Access Compliance Report Public Rights-of-Way (Pedestrian Signals)

Main Street: **E_CHAPMAN_AVE** Cross Street: **ESPLANADE_ST** Location: **SE**

ADA ID: **SGAT210927141339** Signal Type: **One Push Button-Non APS** Overall Compliance: **No** Severity Scores: **BTN 1: 10 BTN 2: N/A No BTN: N/A**

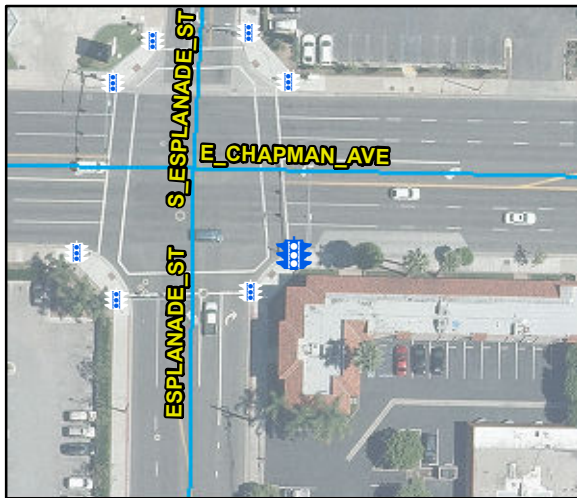
Yes	B 1 Diameter (in)	2.25	N/A	B 2 Diameter (in)	N/A
N/A	B 1 Crossing Direction	N	N/A	B 2 Crossing Direction	N/A
No	B 1 DistanceTo XWalk (in)	75	N/A	B 2 DistanceTo XWalk (in)	N/A
Yes	B 1 DistanceTo Curb (in)	27	N/A	B 2 DistanceTo Curb (in)	N/A
	Parcel Identification Number	392-191-12			
	Google Street View Link				
	http://www.google.com/maps/@?api=1&map_action=pano&viewpoint=33.78763909,-117.80945048

Possible Solutions: Replace Signal Push Button With APS Button. Remove & Relocate Sign.
